Addendum #7

CONSIDER IN YOUR RESPONSE/BID THE FOLLOWING ITEMS OF ADDITION, DELETION OR CLARIFICATION. INDICATE IN THE SPACE PROVIDED ON THE RESPONSE/BID FORM THAT YOU HAVE RECEIVED AND INCLUDED FOR THE REQUIREMENTS OF THIS ADDENDUM. SICKKIDS MAY, IN ITS SOLE DISCRETION ANSWER SIMILAR QUESTIONS FROM VARIOUS RESPONDENTS ONLY ONCE.

RE: QUESTIONS AND ANSWERS, SPECIFICATIONS, DRAWINGS AND DOCUMENTS

Drawing Title
LEVEL 2 ENLARGED FLOOR FRAMING PLAN

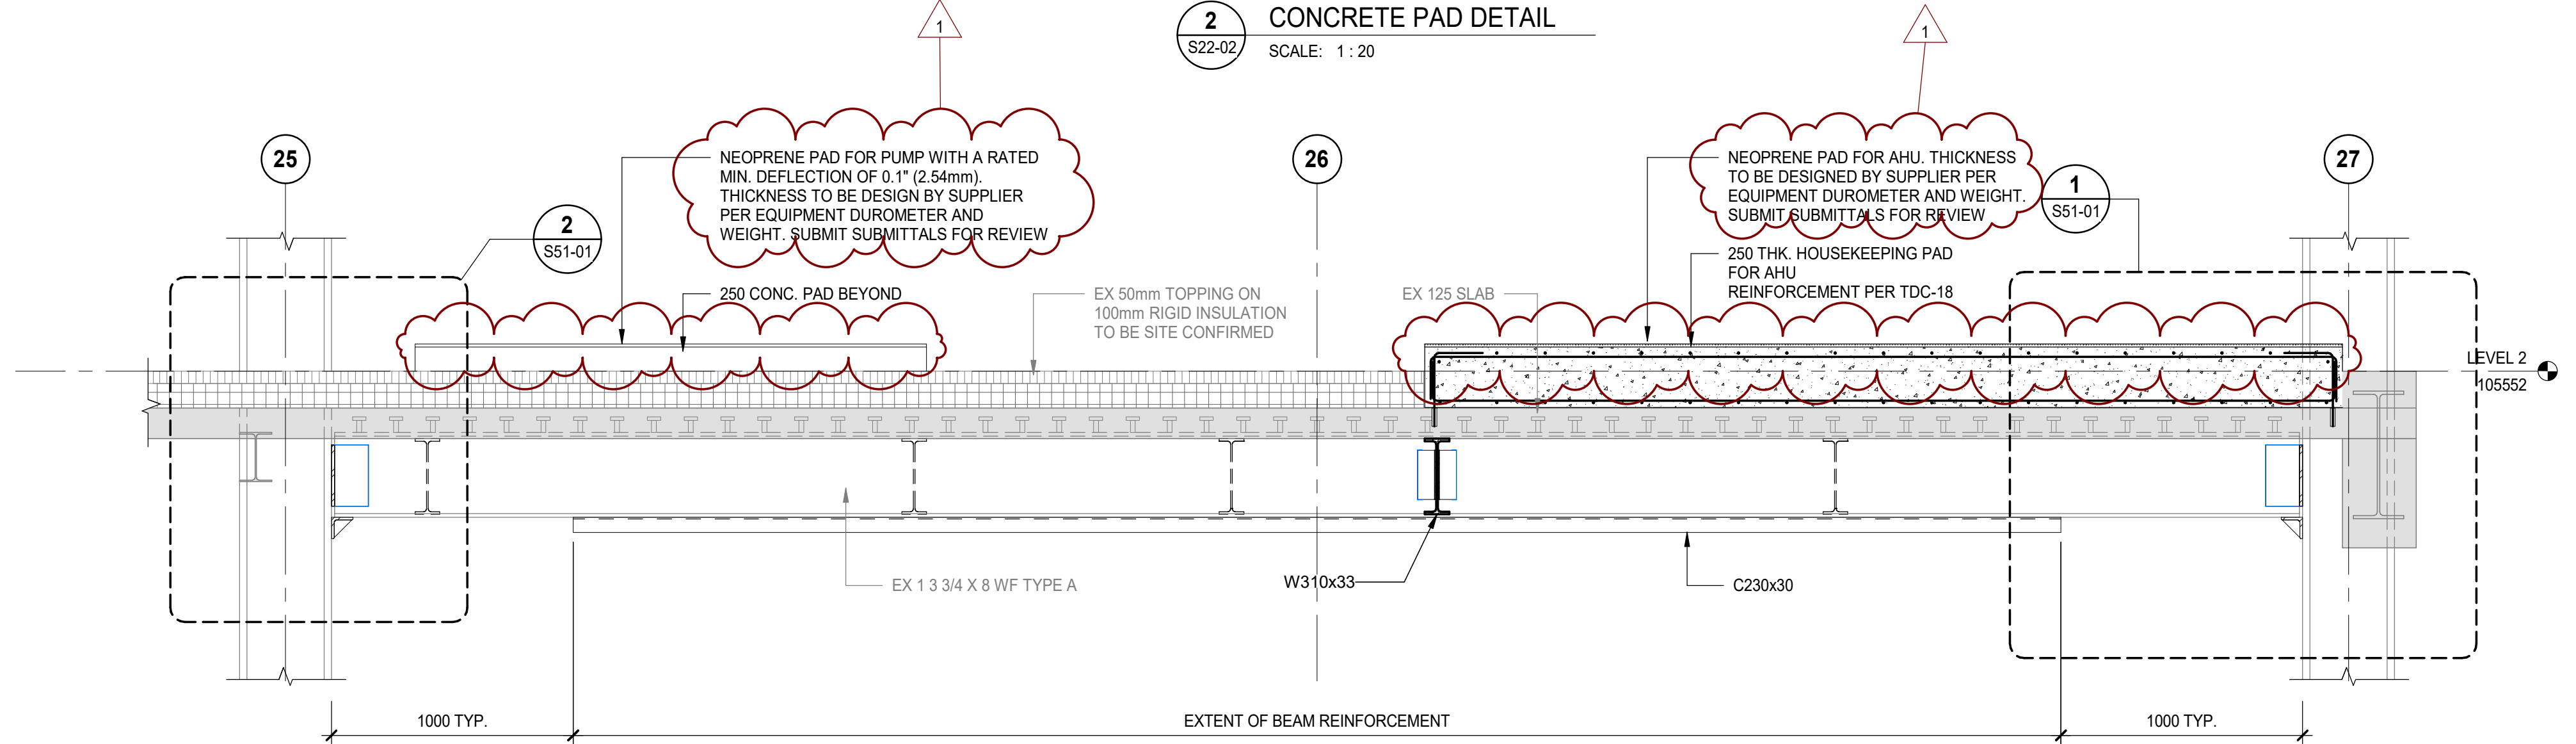
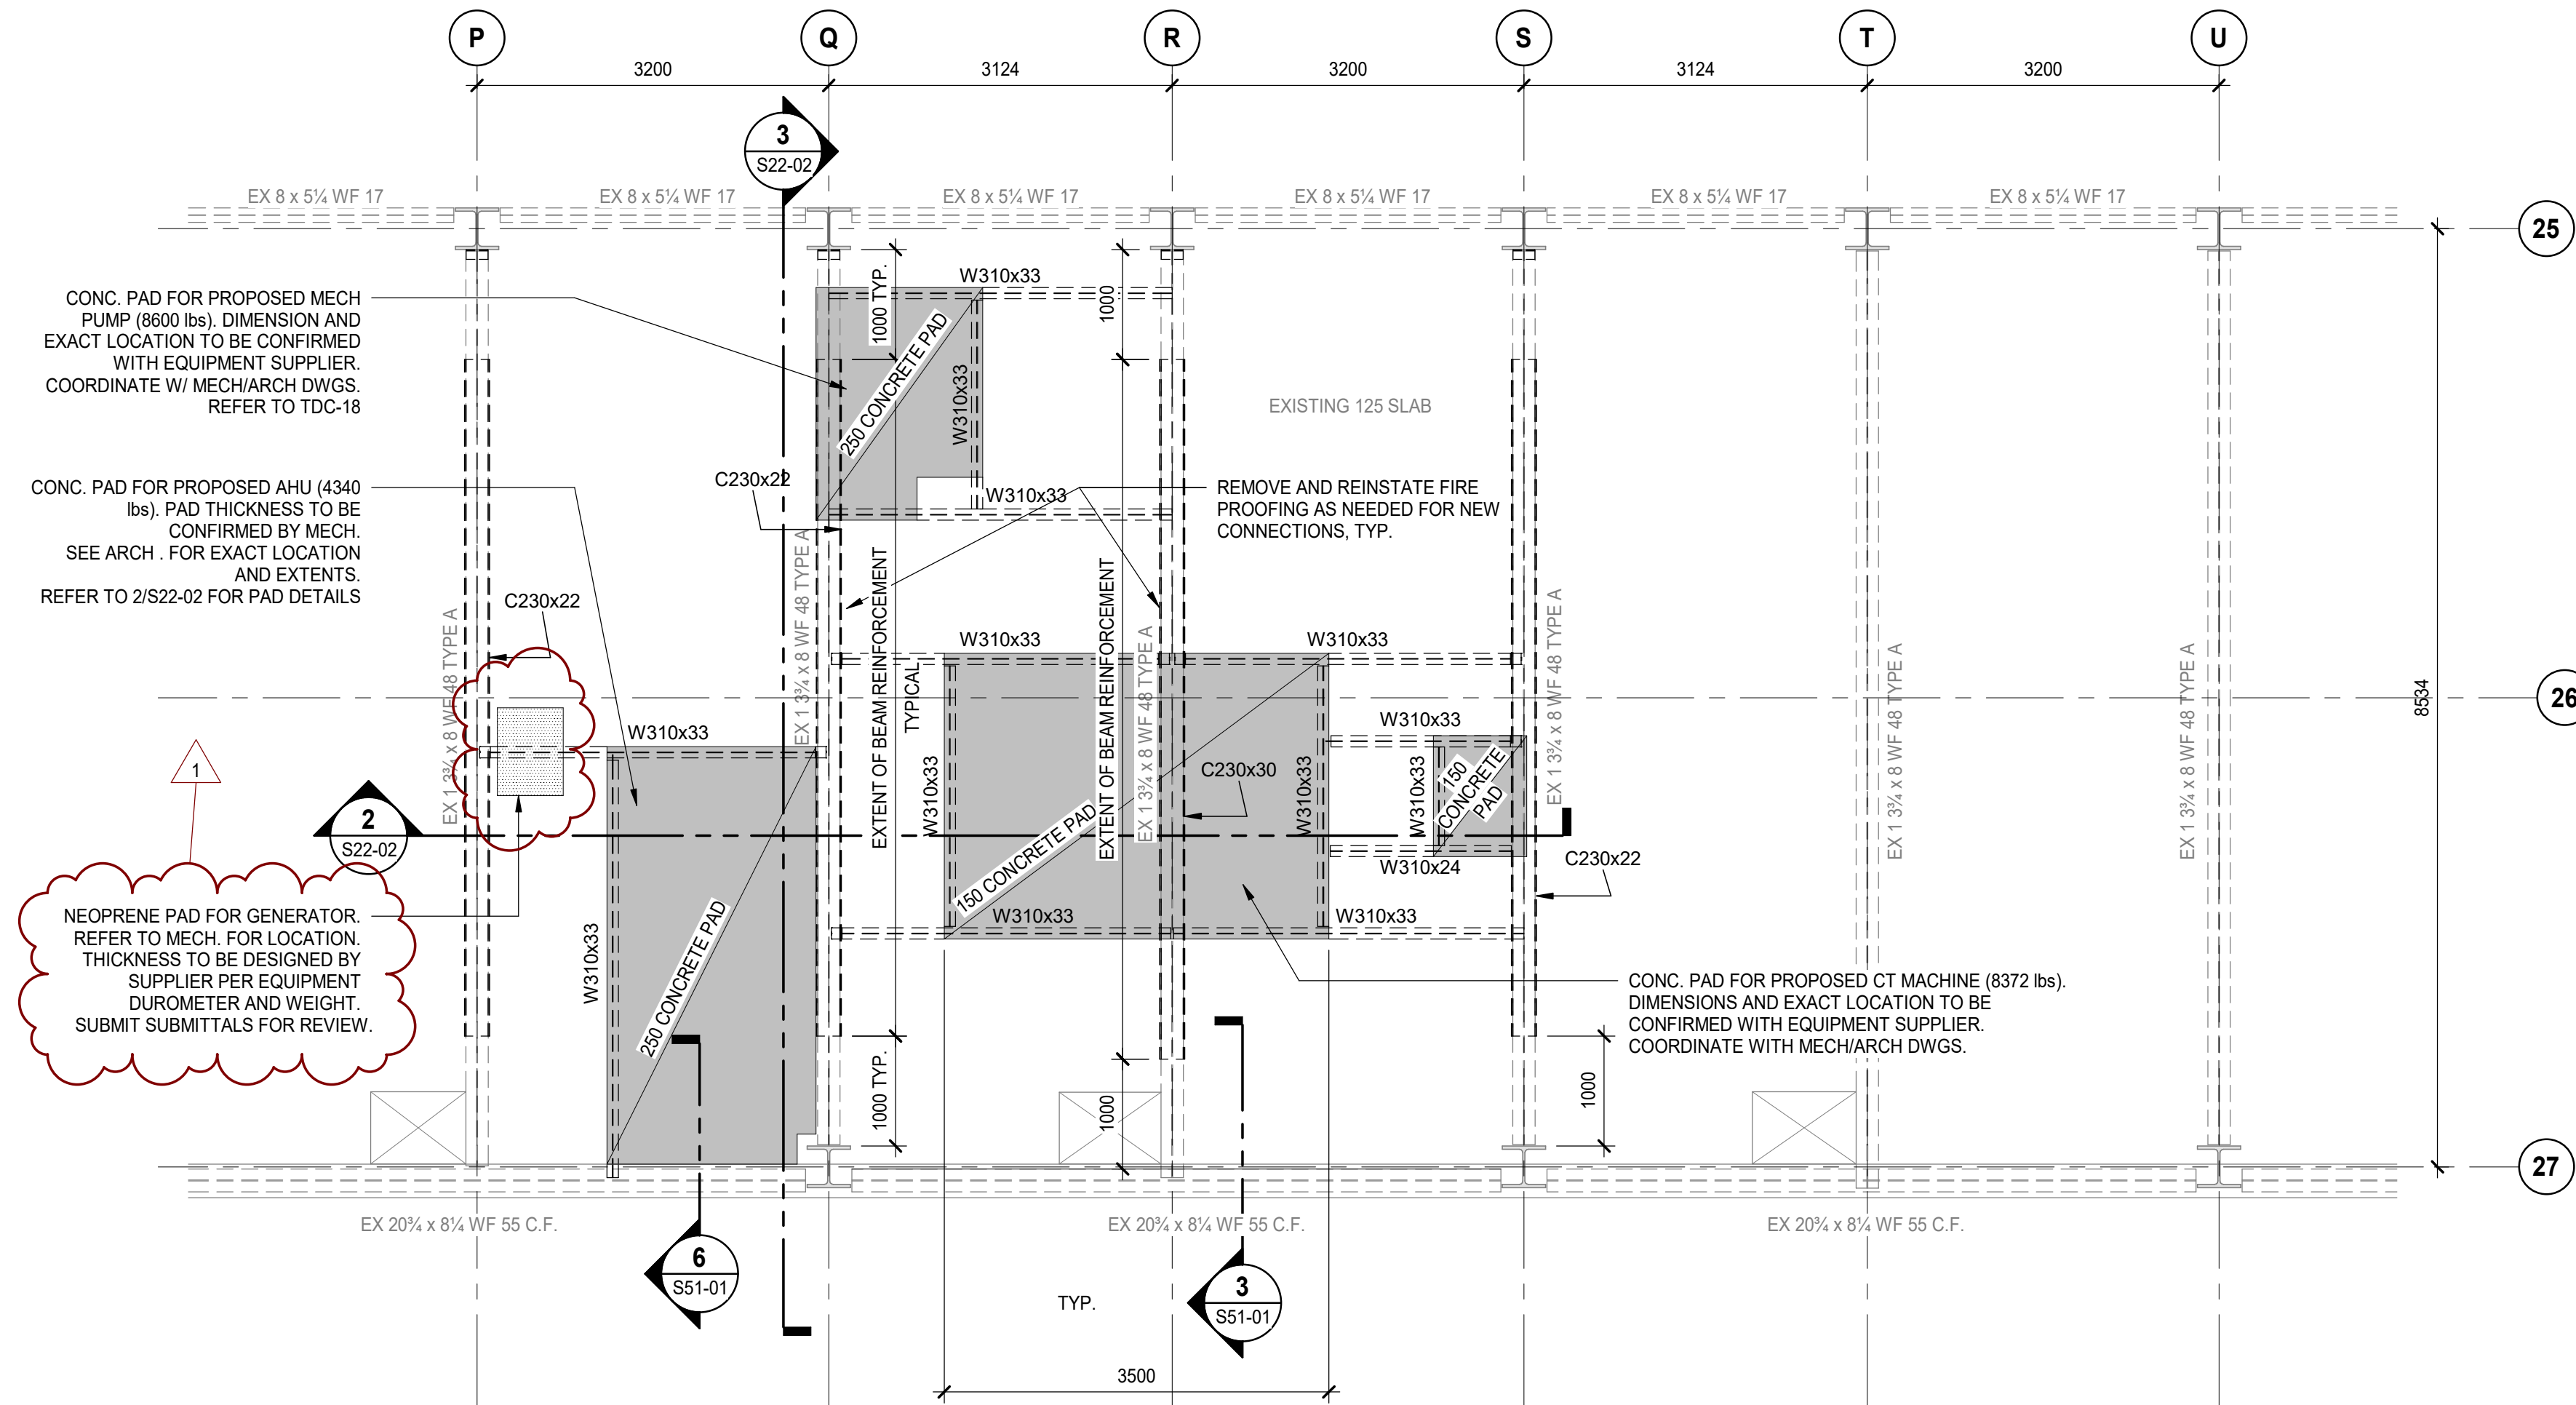
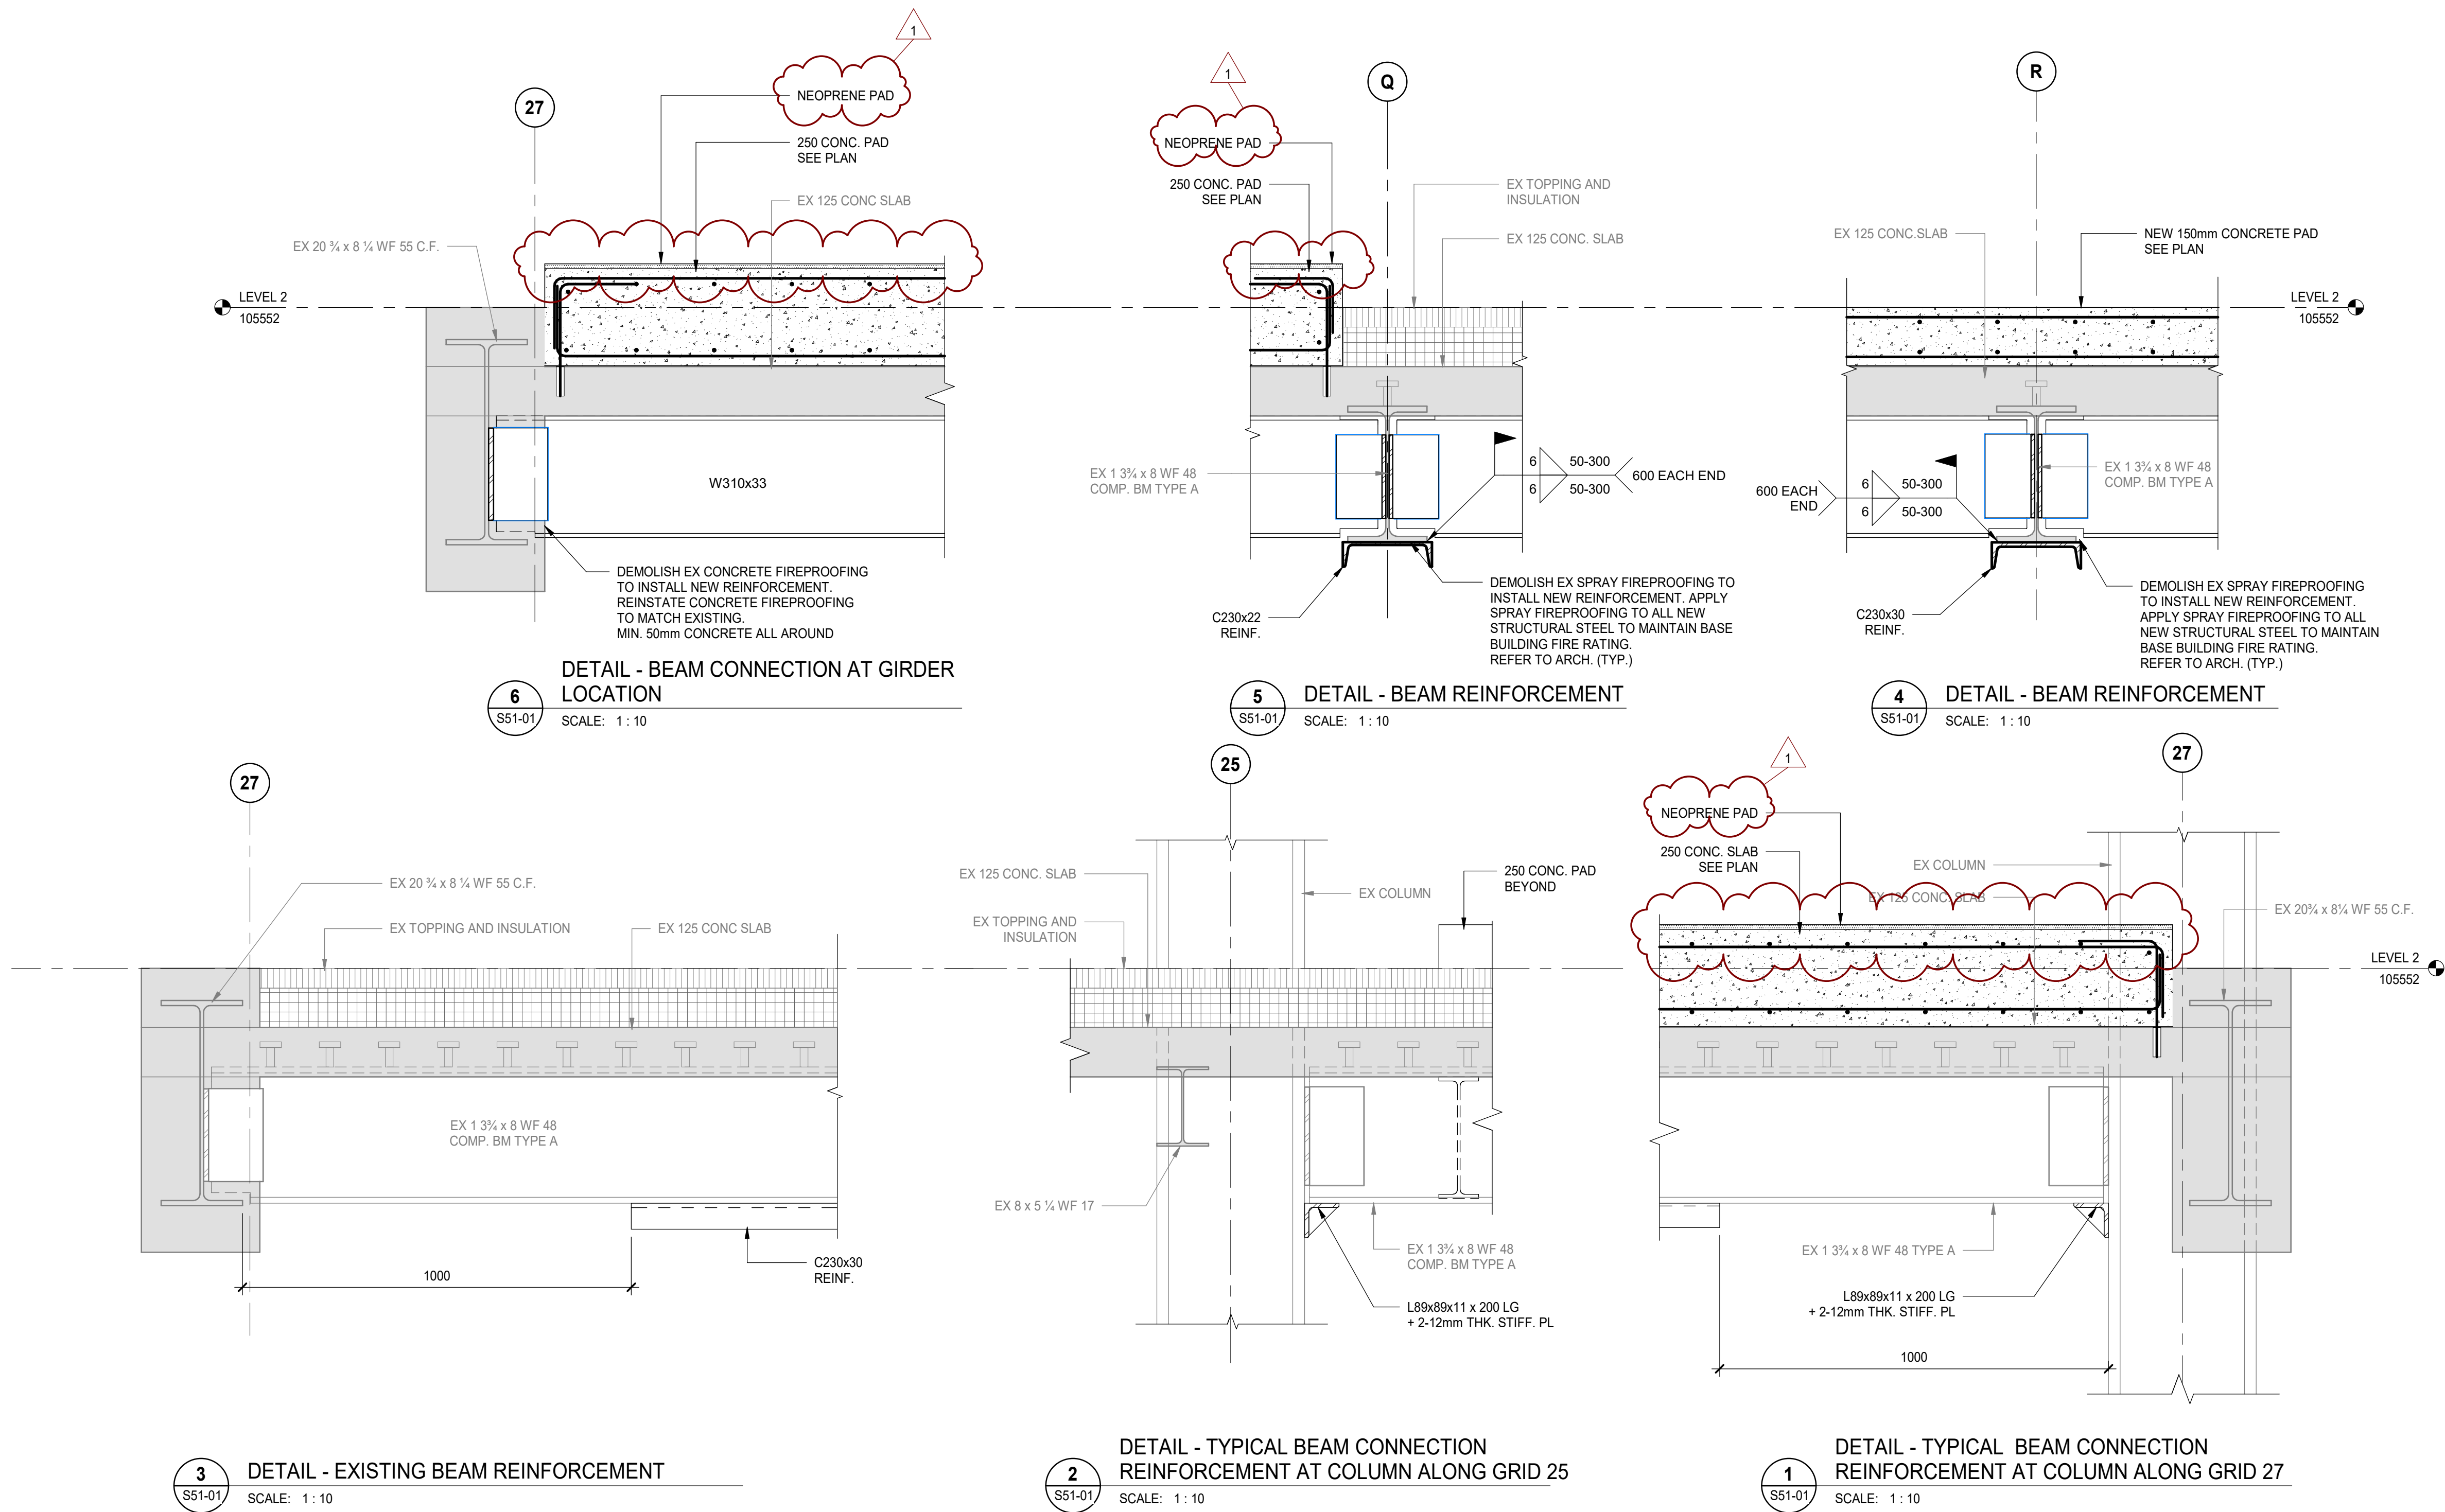
- .7 Drawing AB-02-BW-06 TYPICAL DETAILS
Louvres identified
 - .8 Drawing S02-01 TYPICAL DETAILS
Steel Dowel Clarification
 - .9 Drawing S22-02 LEVEL 2 ENLARGED FLOOR FRAMING PLAN
Various updates on Neoprene pads for the housekeeping pads.
